WEST SUSSEX COUNTY COUNCIL CONSULTATION

TO:	Horsham District Council FAO: Bethan Tinning
FROM:	WSCC – Highway Authority
DATE:	7 April 2026
LOCATION:	99 Blackbridge Lane Horsham West Sussex RH12 1RU
SUBJECT:	DC/26/0413 Erection of a detached two-bedroom dwelling with associated parking and access.
DATE OF SITE VISIT:	n/a (Desktop study undertaken)
RECOMMENDATION:	Modifications/more information required

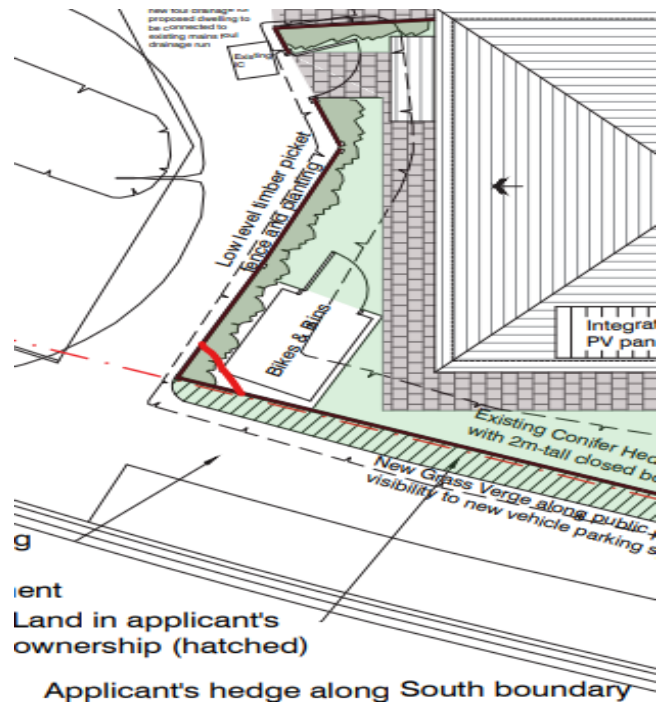
1. *Access driveway visibility* - The access driveway should have 2.0 x 2.0m pedestrian intervisibility splays provided either-side of it (see indicative red lines – applicant will need to accurately plot these on an amended drawing. Fence will need lowering to 0.6m high alongside sub-station access):

Additionally, it is also recommended that any fence line at corner with existing path be shown angled-back to provide for improved pedestrian intervisibility at that point:
